lune 1990)		NT OF THE INTERIOR		Budget Bureau No. 1004-0135 Expires: March 31, 1993	
	BUREAU OF	LAND MANAGEMENT		5. Lease Designation and Serial No.	
	SUNDRY NOTICES	I.C029392B 6. If Indian, Allottee or Tribe Name			
Do not use	this form for proposals to di		y to a different reservo		
<u>, </u>	SUBMIT	IN TRIPLICATE		7. If Unit or CA, Agreement Designation	
1 Type of Well			46.2 Aug		
Oil Well	Gas Well Other		MOA 5.2"	8. Well Name and No.	
2 Name of Open	alor		0 C D.	Hinkle B-26#2	
Tom Bo	oyd Drilling Co.,	Inc. (Enerloc Re	esourcesce Inc.)	9. API Well No. 05609	
Address and T	•		ARIESITA	30015 87322001	
616 Me	echem Dr., Ruidoso, ell (Footage, Sec., T., R., M., or Survey D	10. Field and Pool, or Exploratory Area Shugart, Yates, 7-Rive			
	ell (Pootage, Sec., I., R., M., or Survey L	Suesition Arrandourg

Permanent Abandonment of Wells on Federal Lands

Conditions of Approval

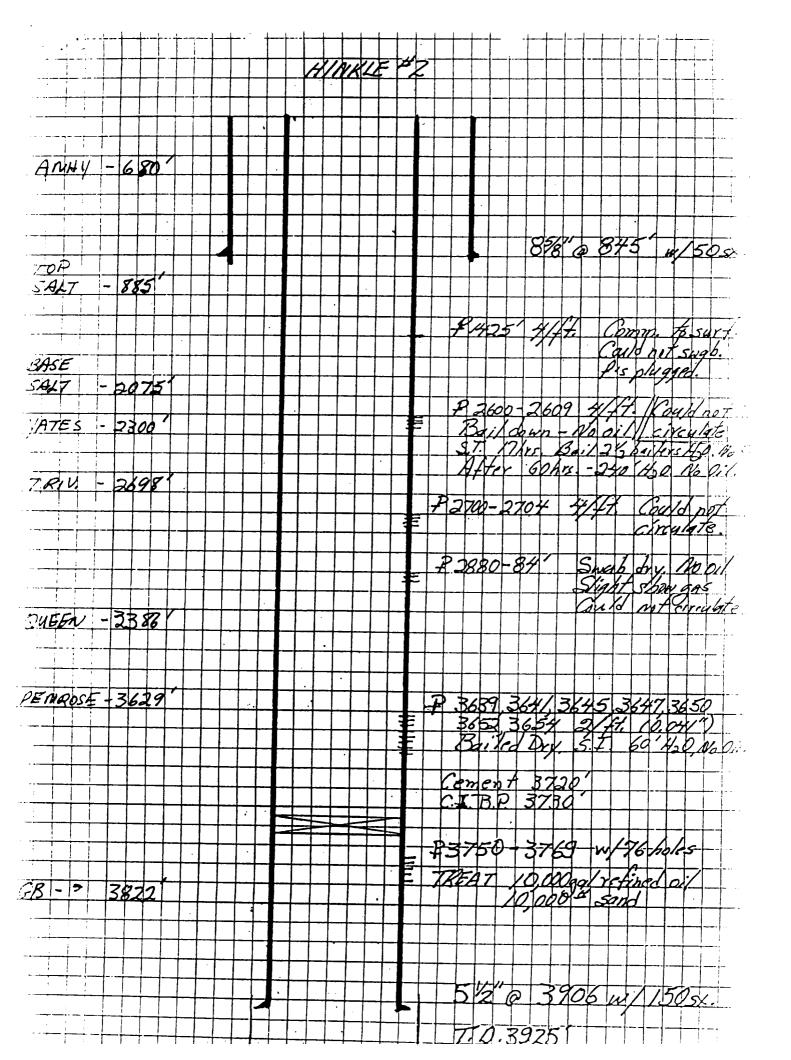
- Cr	HECK APPROPRIATE BOX	S) TO INDICATE NATO	THE OF NOTICE, HER	ORI, OR OTHER DATA	
TY	PE OF SUBMISSION	TYPE OF ACTION			
X	S Notice of Intent	XX Abandonm	ent	Change of Plans	
	_	Recompleti		New Construction	
Subsequent Report		Plugging Back		Non-Routine Fracturing	
	_	Casing Rep	pair	Water Shut-Off	
Final Abandonment Notice		Altering Casing		Conversion to Injection	
		Other	· 	Dispose Water	
				(Note: Report results of multiple completion on We'. Completion or Recompletion Report and Log form	
Describe Propo	sed or Completed Operations (Clearly state a	Il pertinent details, and give pertinent of	lates, including estimated date of sta	rting any proposed work. If well is directionally drilled	
	in halo open and true vertices			ent plum (Class UCH	
	6/gal.)from 3720 to		1120. Spot cem	ent plug (Class "C",

9.016/gal. mud fr		י מי		
	cement plug from				
	t mud from 2550' to				
			and anat mud	haak +a 501	
6 Spot	t cement plug from	501 hook to 315'	and spot mud	Dack to but,

0.2001	5/8" casing.	oo back to sur	race. Pump cem	ent between 5 1/2" casin	
		Postoro			
1.Frec	et dry hole marker.	nestore.

Signed	Title President	Date_	6/30/94
(This space for Federal or State office use) Boyd Approved b (ORIG. SGD.) JOE G. LARA	PETROLEUM ENGINEER	Date	10/27/94
Approved b (ORIG. SGD.) JOE G. LARA Conditions of approval, if any: See attached. Leaving 100	Also perf 5/2" rsg @ 845 emt Dlug Srom 795'-895	4	Squeeze ON
